# Coffs Harbour Highway Planning

Sapphire to Woolgoolga section

**ENVIRONMENTAL ASSESSMENT SUBMISSIONS REPORT**  
**JULY 2008**

## SUBMISSIONS REPORT

**FIGURE 4.1A** PROPOSED CHANGE TO PROPERTY ACQUISITION AREA

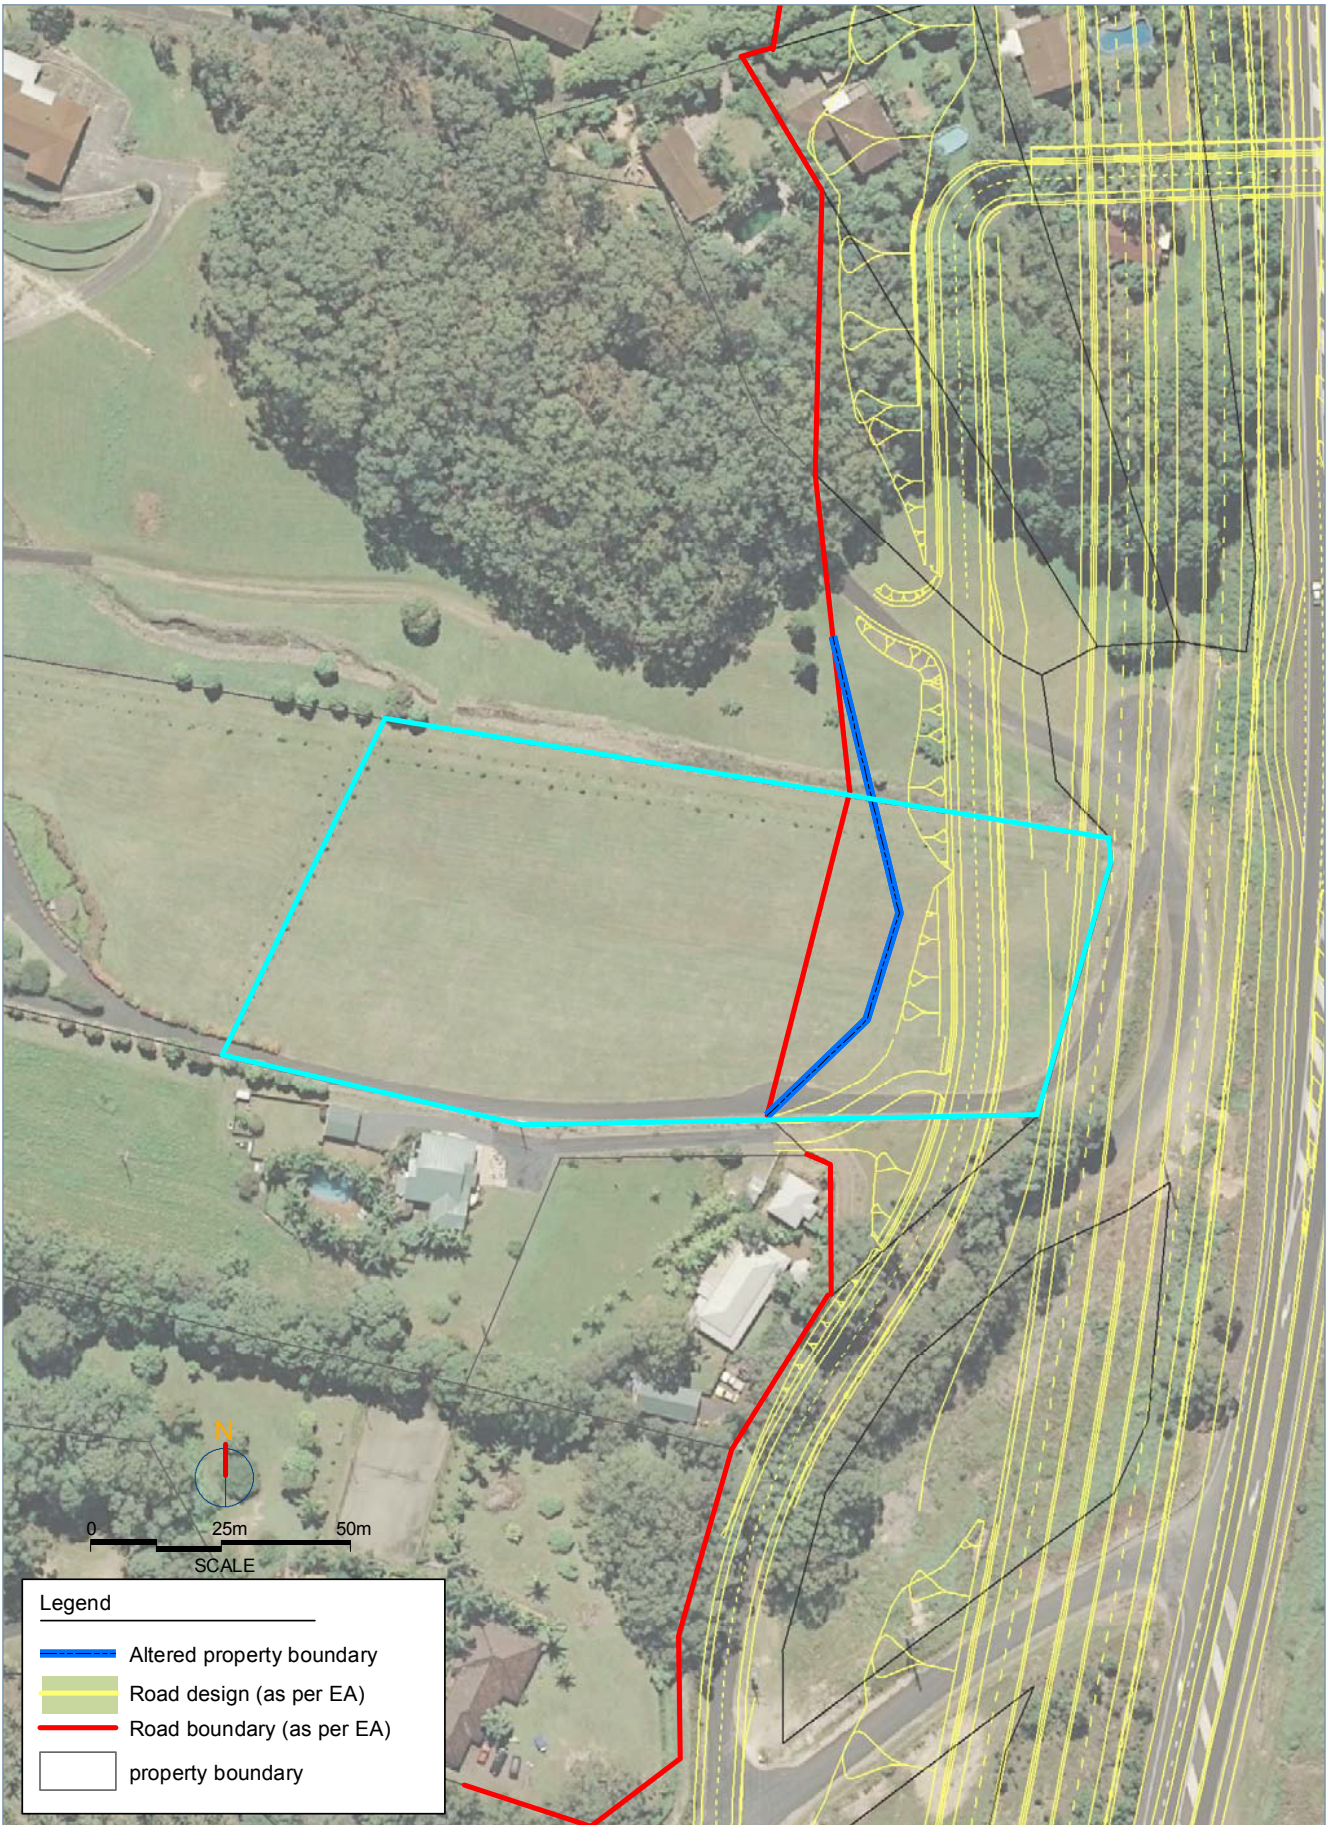
- Respondent strongly objects to the compulsory acquisition of their property. The design shows the proposed new road reserve boundary in close proximity to the respondent's front door and there are plans to take land at the back of the property which will cut the access between the respondent's property and the adjacent property which belongs to a relative.

The Proposal design at this location has been reviewed and revised. It is proposed to shift the boundary to the east, closer to the existing property boundary. This would reduce the area of acquisition for this property by approximately 770m<sup>2</sup>.

- Property Effect No. 16; located in Hunter Close (refer Figure 4.1a): It is proposed to shift the boundary to the east, closer to the existing property boundary, reducing the required area of acquisition by approximately 770m<sup>2</sup>.
- Property Effect No.113 located at Newmans Road (refer Figure 4.1b): It is proposed that the road reserve boundary at this location be refined reducing the required area of acquisition by approximately 0.37 ha.
- Property Effect No.125; located in Bark Hut Road (refer Figure 4.1c): It is proposed that the road reserve boundary at this location be refined reducing the required area of acquisition by approximately 0.46 ha.
